Houston Lighting & Power

June 15, 1988  
ST-HL-AE-2683  
File No.: G9.1, R5  
10CFR50

South Texas Project Electric Generating Station  
Unit 2  
Docket Nos. STN 50-499  
Annotated FSAR Revisions Regarding  
the Revised Unit 2 Cycle 1  
Core Design/Energy Requirements

Attachment: Annotated Revisions to FSAR Chapters 1, 4 & 15  
and affected NRC Question Responses

Figure 15.4-7 B

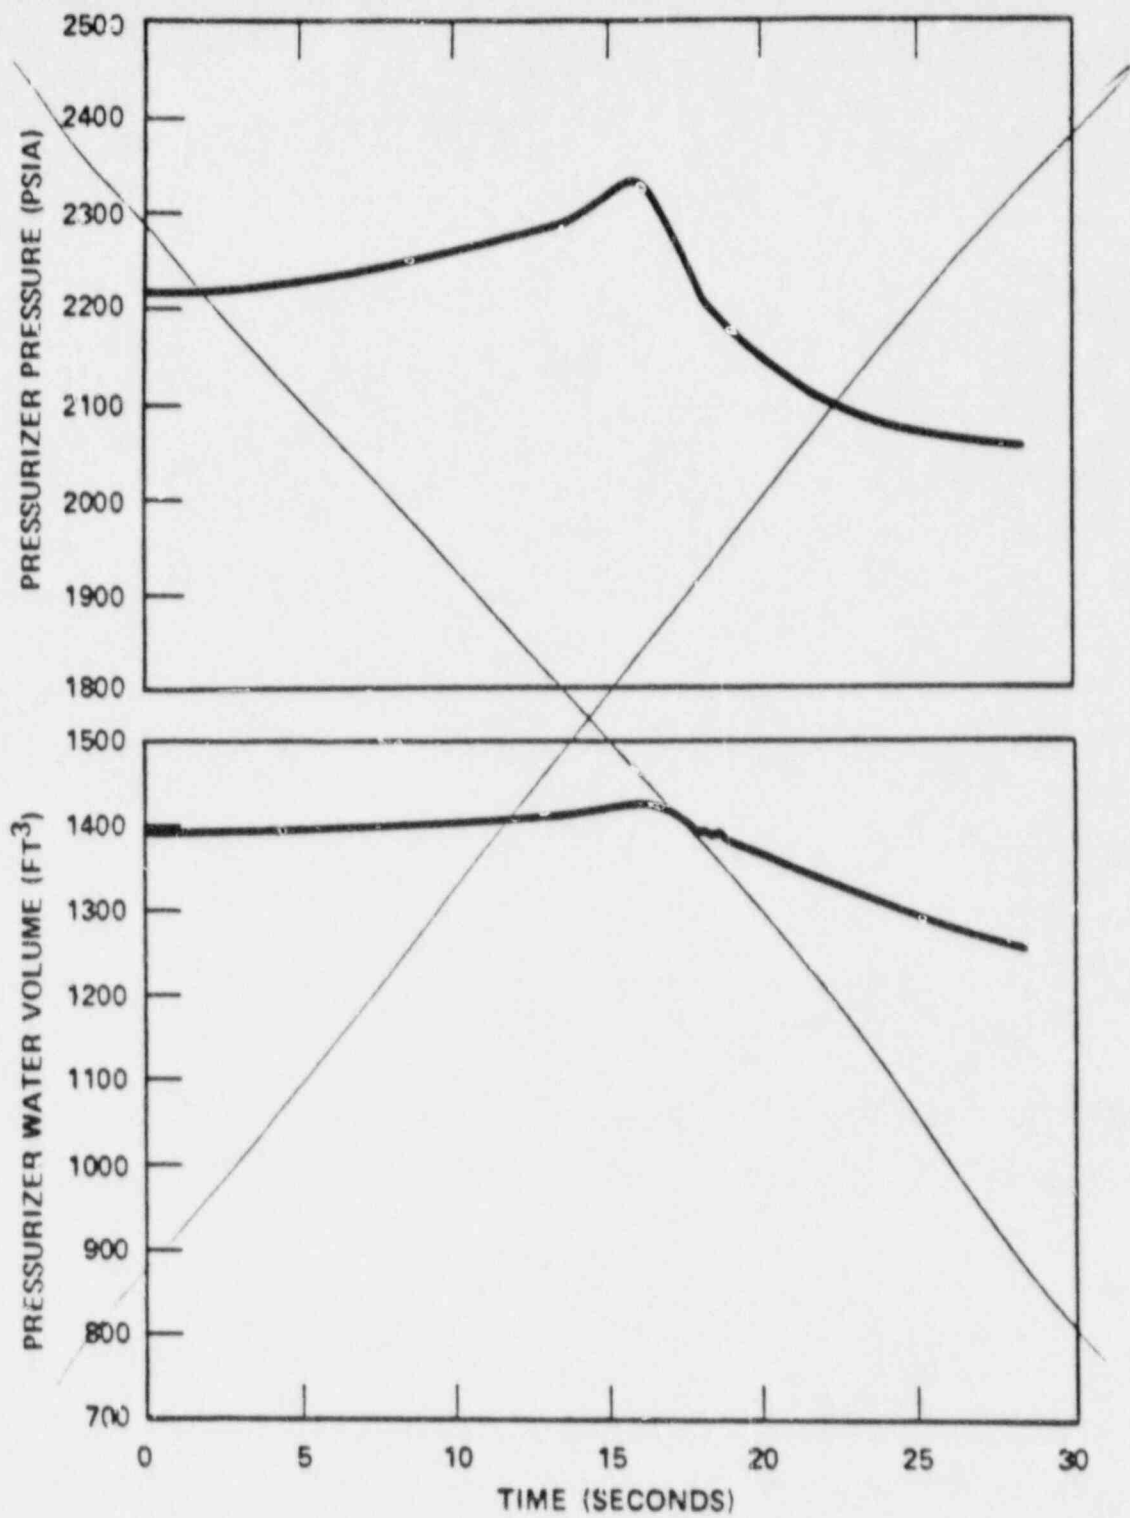
*Replace with  
Following 2 pages*

PRESSURIZER PRESSURE & WATER  
VOLUME TRANSIENTS FOR  
UNCONTROLLED ROD WITHDRAWAL  
FROM FULL POWER WITH MINIMUM  
FEEDBACK & 5pcm/sec WITHDRAWAL RATE  
Figure 15.4-8 A

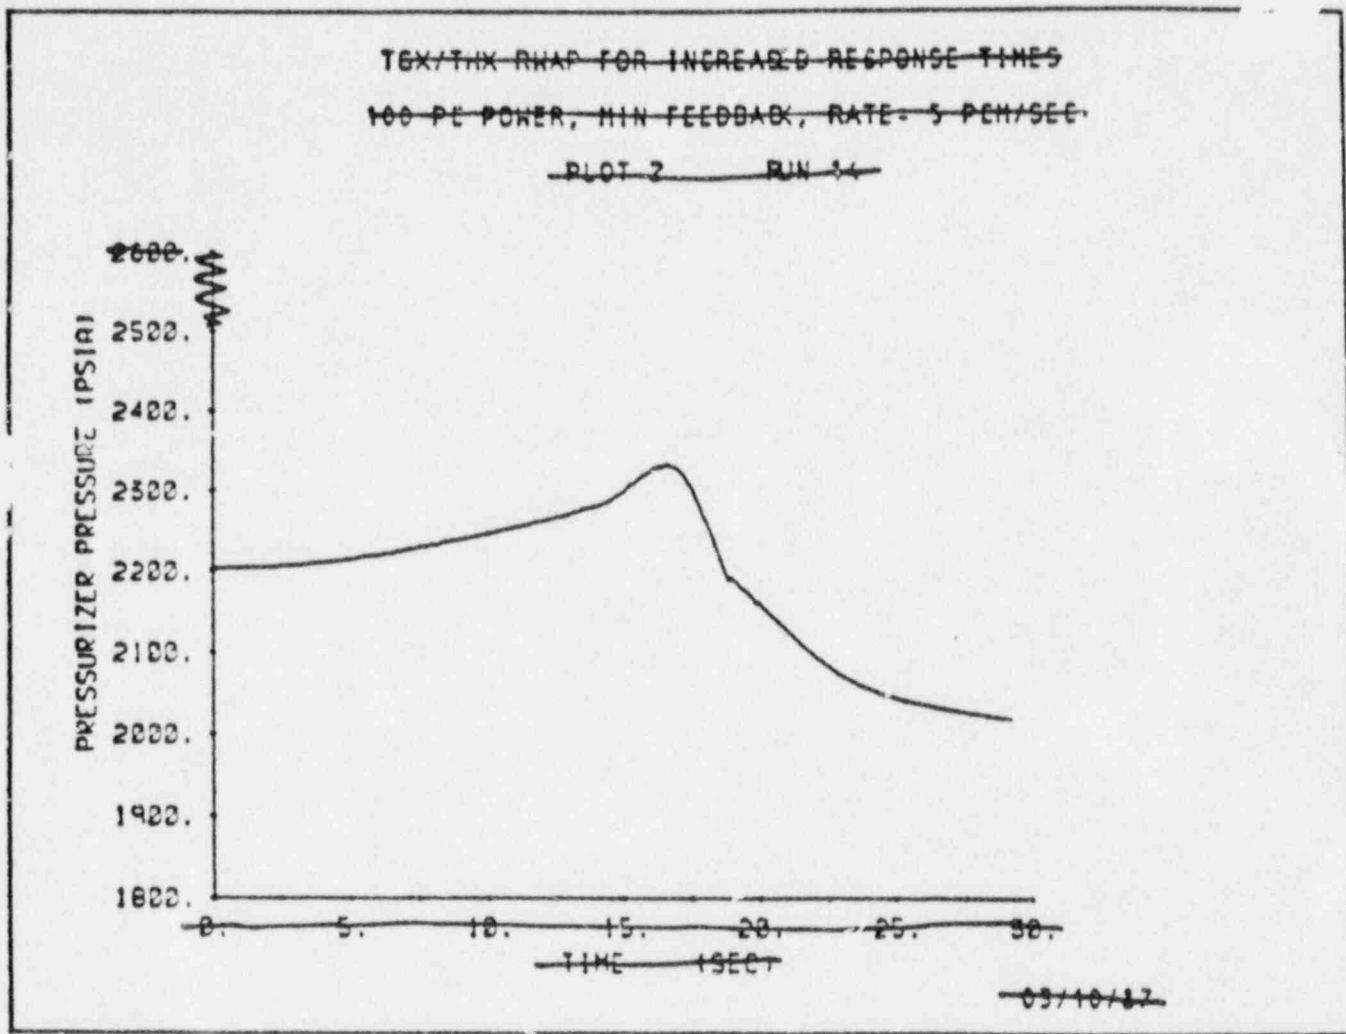
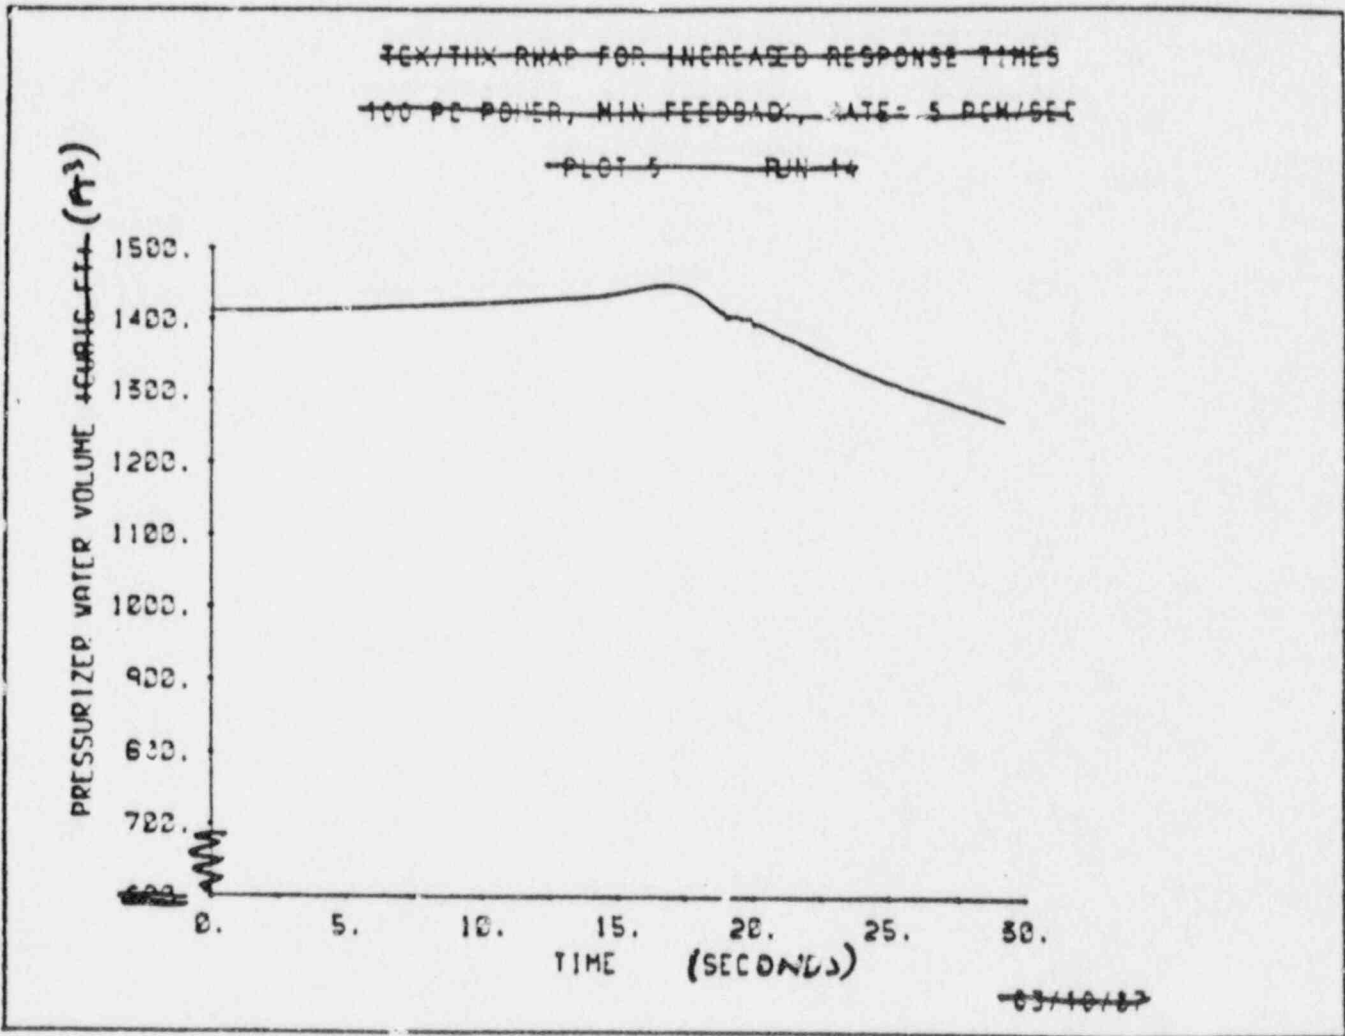
Replacement Figure 15.4-8 A (top curve)

Replacement Figure 15.4-8A (bottom curve)

Figure 15.4-10 A

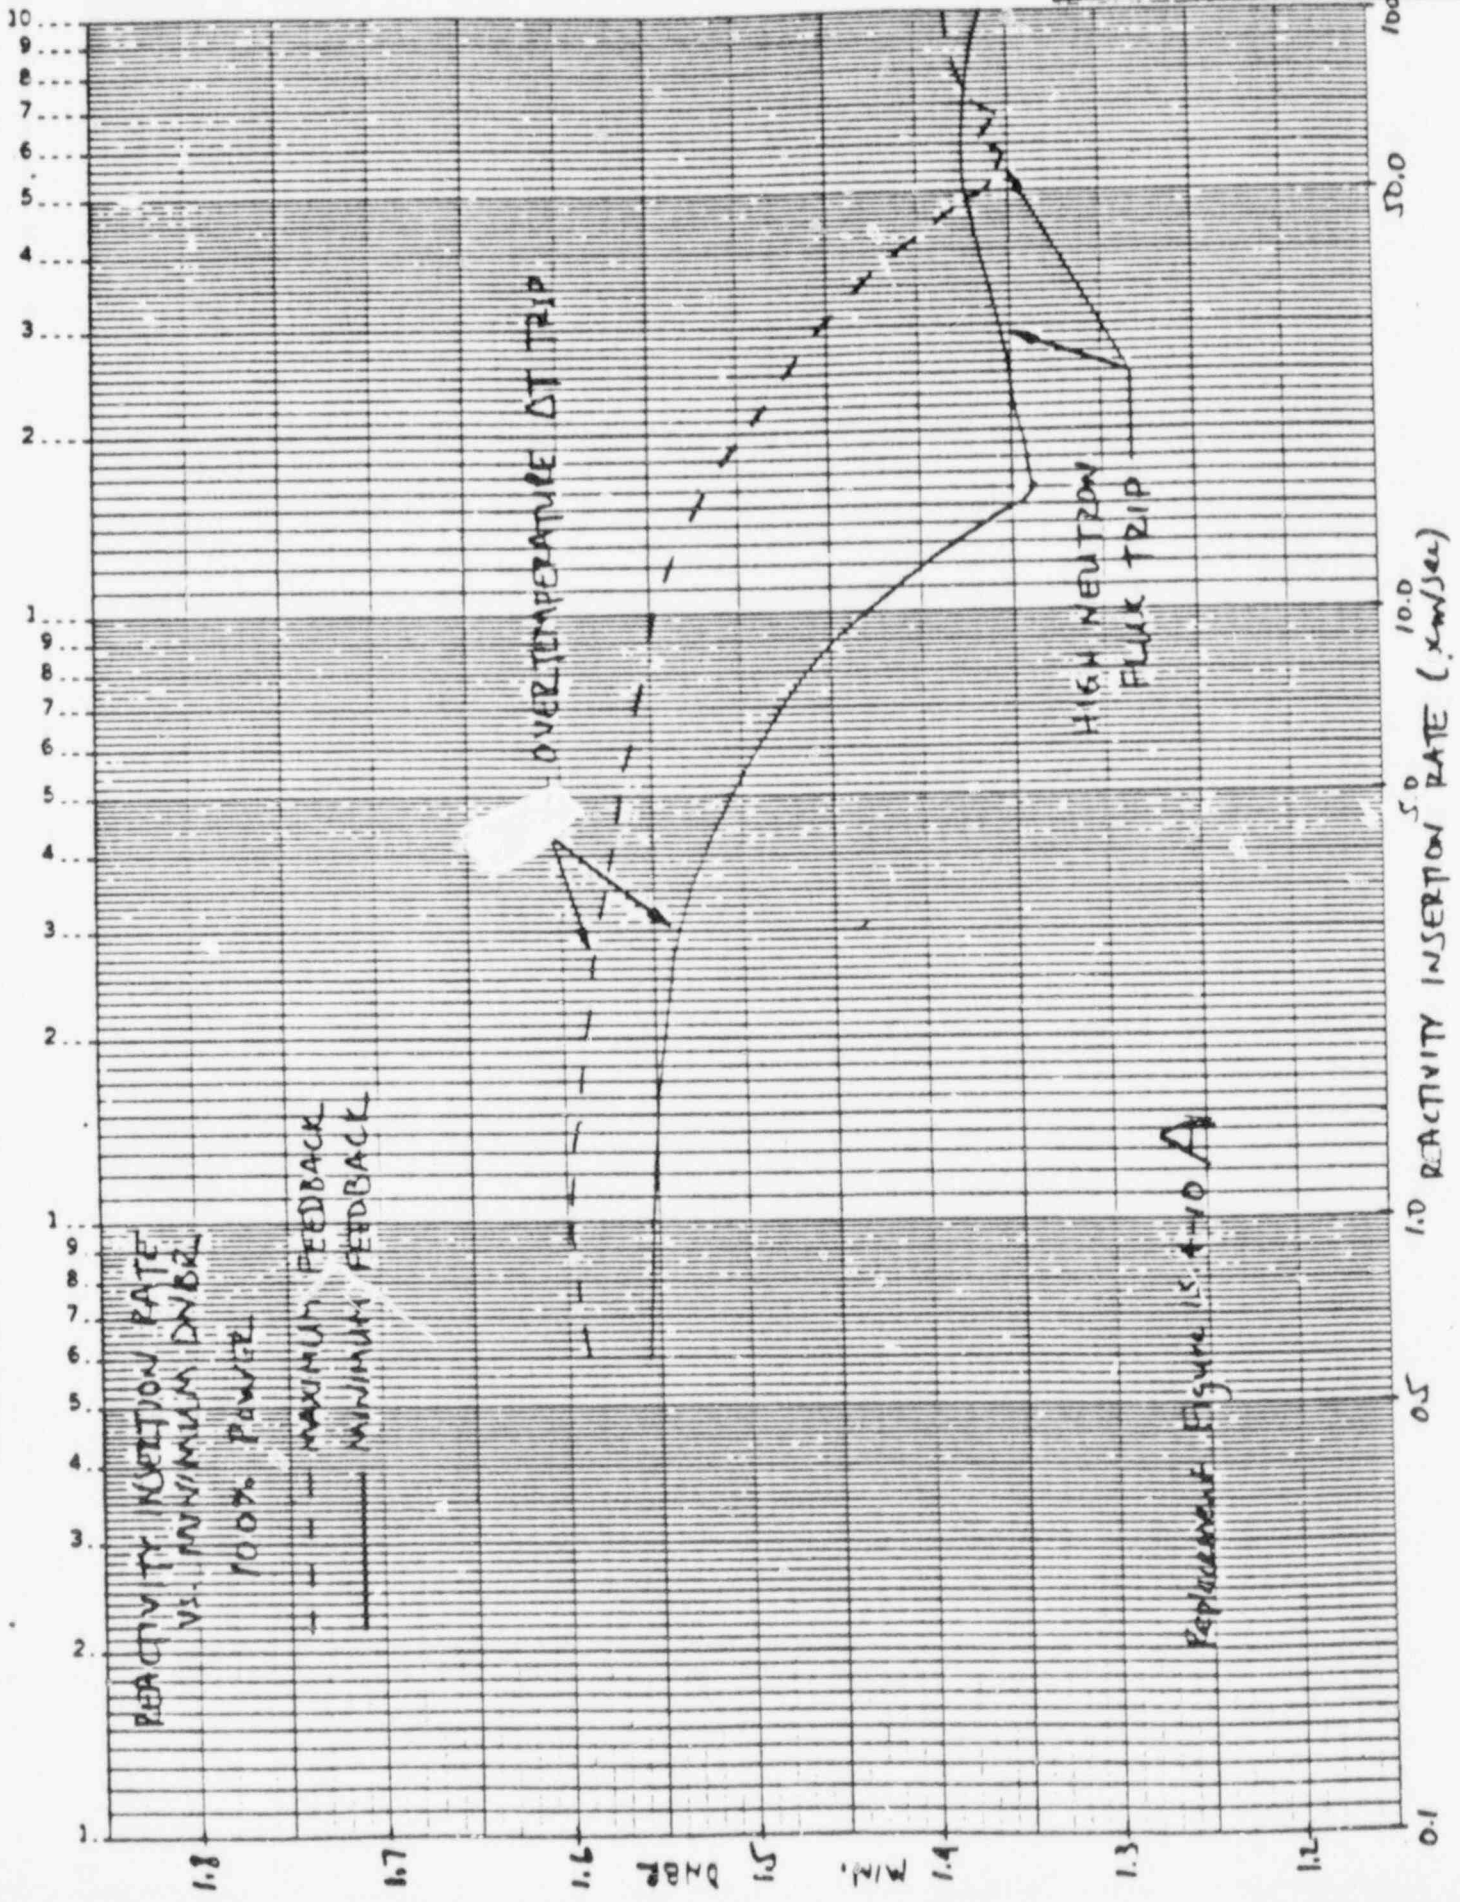
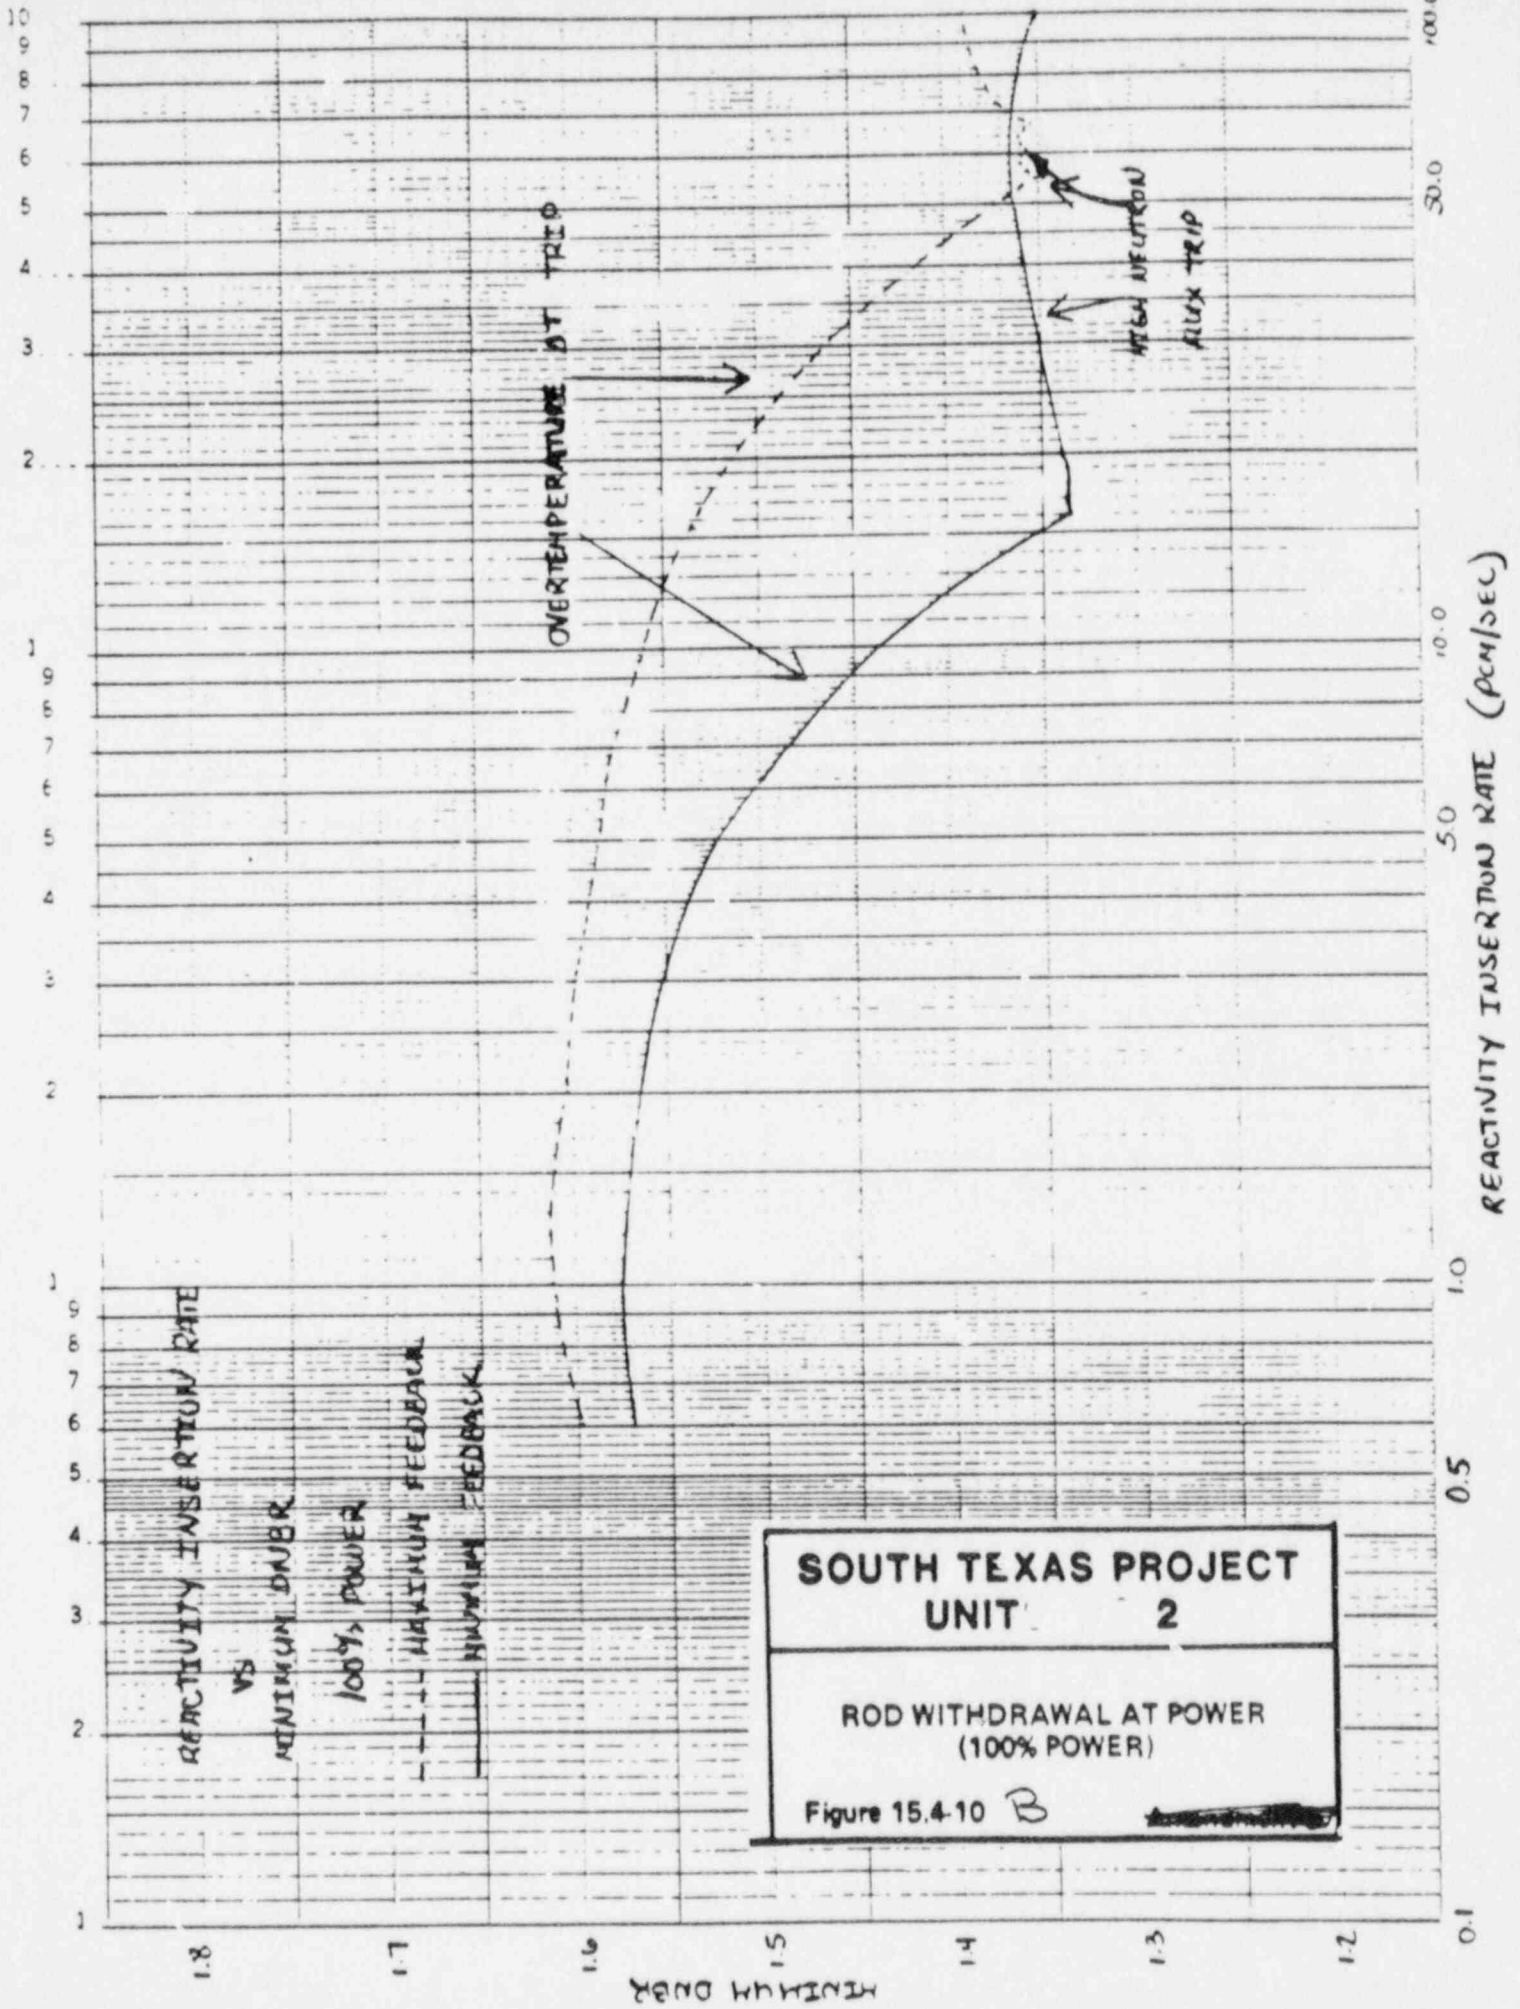
Replace with  
following page

Replacement Figure 15.4-10 A
